Boeing 737NG Stabilizer trim motor (STM)

- Current Part Number: 6355C0001-01 Mod 9
- Under Development: 6355C0001-02

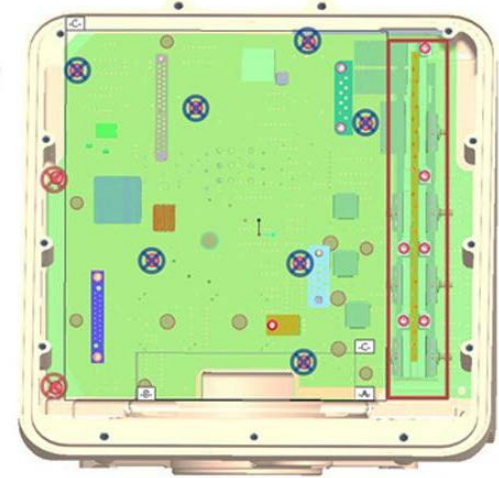
- Horizontal Stabilizer Trim Motor (STM) meets its reliability requirements. However, due to operator feedback, design improvements have been made and continue to improve field reliability
- Primary failure mode is solder joint fatigue of the memory chip due to a combination of bending, vibration and thermal expansion stresses

- During joint Eaton / Boeing NFF investigations, an intermittency of the U8 component of the 6355-0230-13 Control PWA was identified
- The intermittency was determined to be caused by a potential tolerance stack-up that creates mechanical stress across the 6355-0230-13, ultimately causing the leads of U8 to fracture over time
- Further, Boeing has performed an in-depth analysis of the Horizontal Stabilizer Trim System Wiring design to include ships wiring, switches and production breaks and splices. The results of the Boeing Study show that operators may reduce the No Fault Found test results for the STM by checking the airplane wiring and switching components prior to removal

- Eaton has created a shimming procedure that ensures the 6355-0230-13 is held flat, so that all component leads, including the U8, are free from mechanical stress. This change is identified on 6355C0001 units as Modification 9 (Mod 9)
- After two years in service, the reliability of Modification 9 is higher than the overall population

- Modifications to the memory chip package which is significantly more robust to vibration and thermal expansion
- Design and manufacturing optimizations from Boeing and Eaton investigations, including lessons learned from the 737 MAX qualification
